Special Use Permit Recommendation and Preliminary Discussion

BAR 13-08-05
853 & 901 W Main Street
Tax Map 31 Parcel 169 & 170
853-855 West Main LLC, Owner/ Landmark Acquisitions LLC, Applicant
New Construction

CITY OF CHARLOTTESVILLE
BOARD OF ARCHITECTURAL REVIEW
STAFF REPORT
September 17, 2013

Preliminary Discussion (Revised Plan)

CORNICE MODIFICATIONS

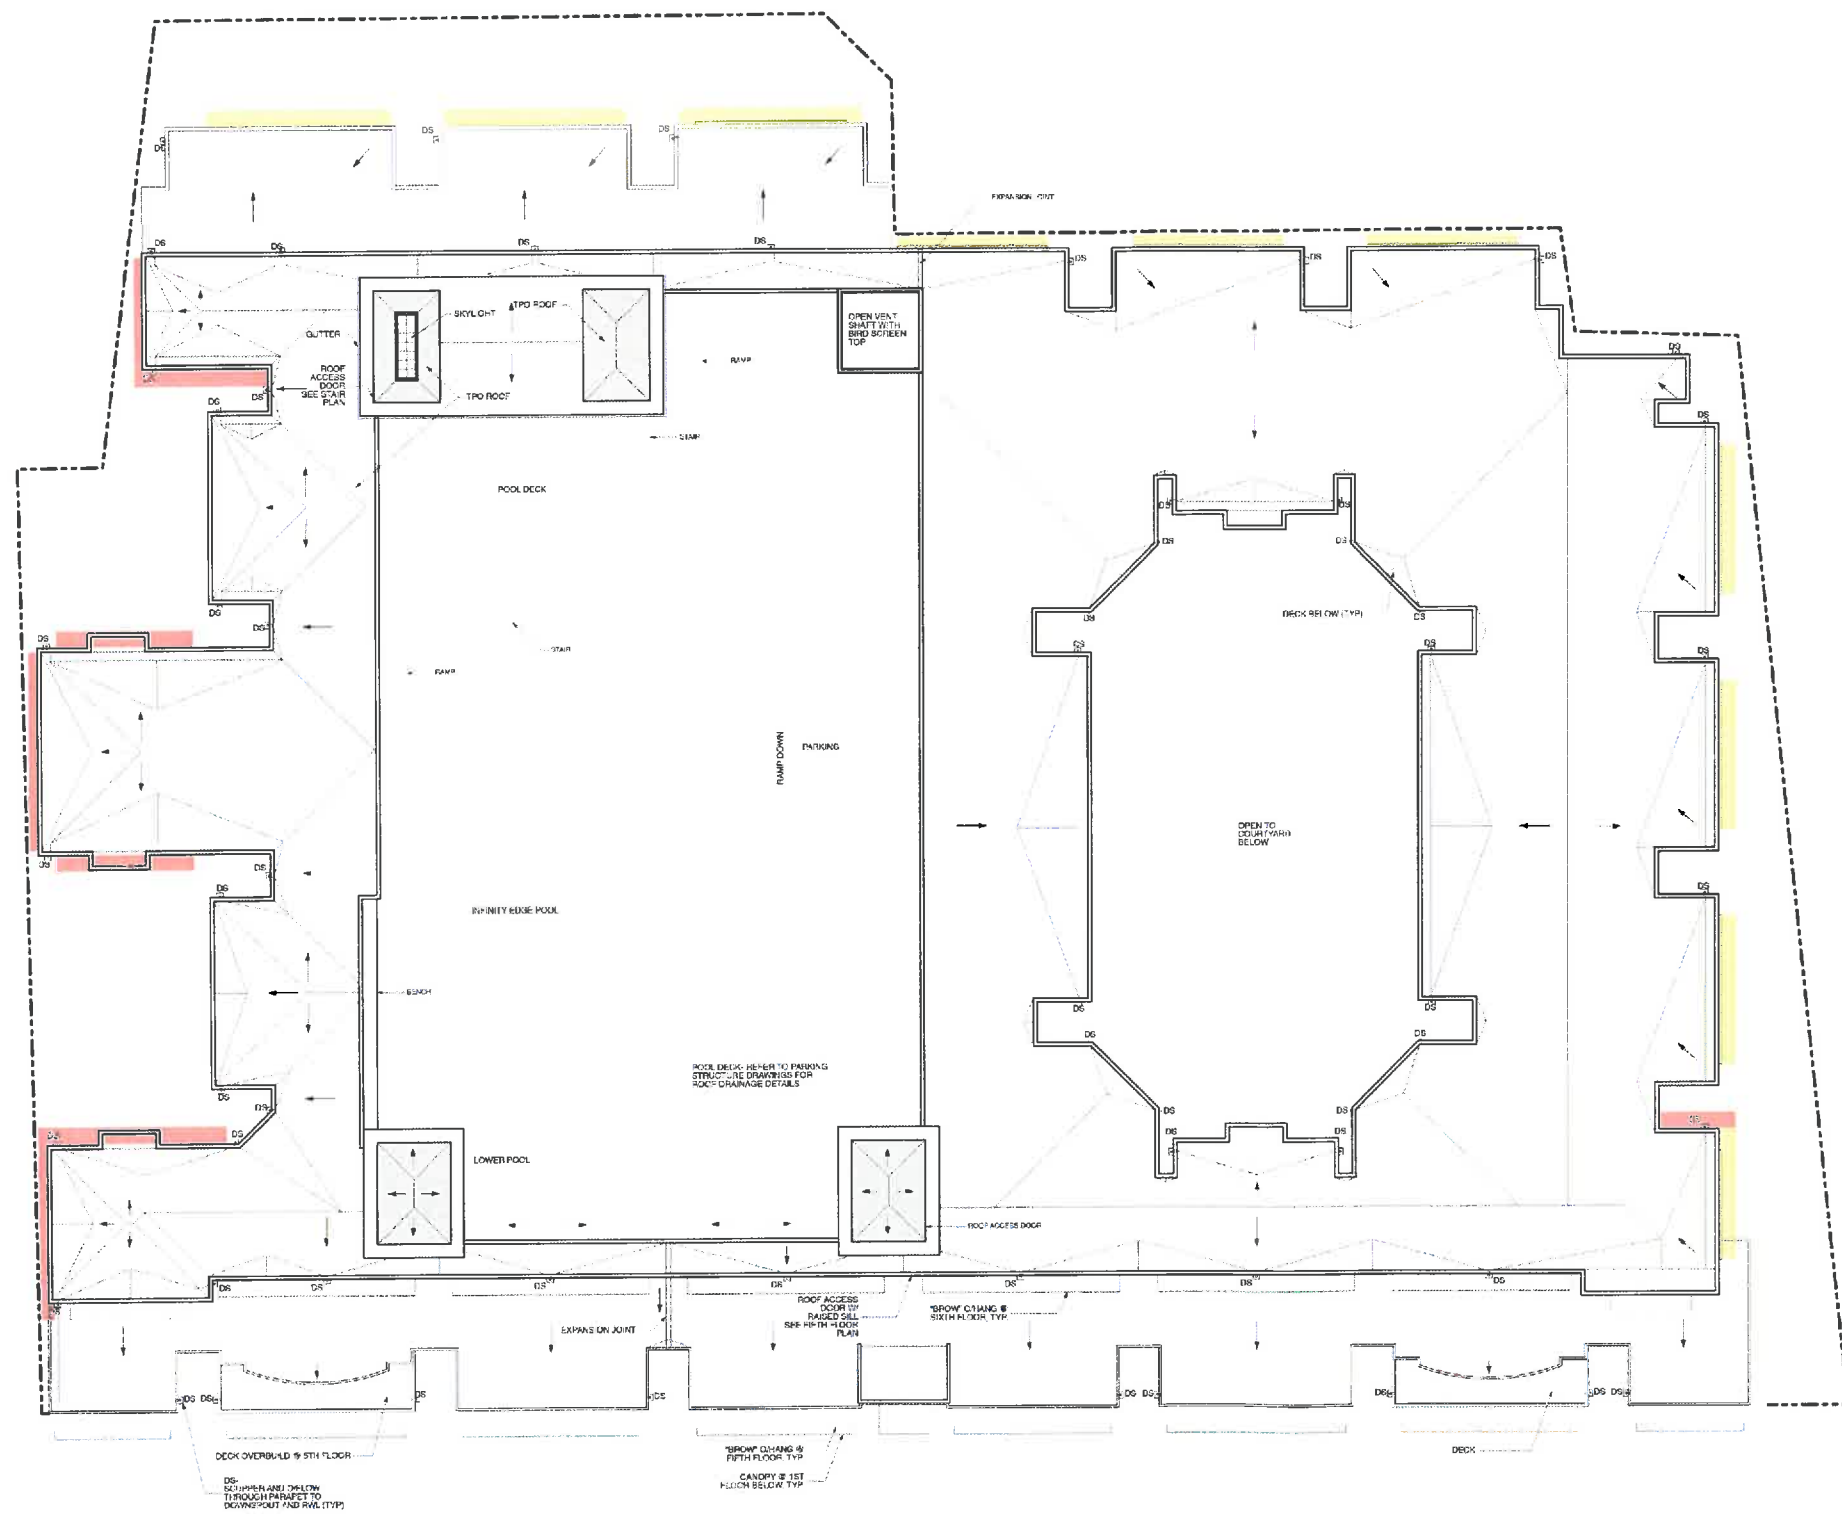
- **Revisit how the entries are marked on West Main Street (not curved canopies).**
- **Brick end walls are good.**
- **Explore a canopy over the garage rather than a header band?**
- **West elevation – keep brick rather than Hardi (all party wall conditions should be brick).**
- **Like ends eroded rather than symmetrical.**
- **Drop down the west end next to the historic building.**
- **Get ground floor as high as possible.**
- **Would like seeing light in courtyard; even better if could see light through the building or in the back of the garage.**

- **Intermittent cornice on stepback area seems busy.**
- **Need to see wall sections for the various conditions.**
- **Suggest large street trees.**

6" - 12" PROJECTION
ELIMINATED
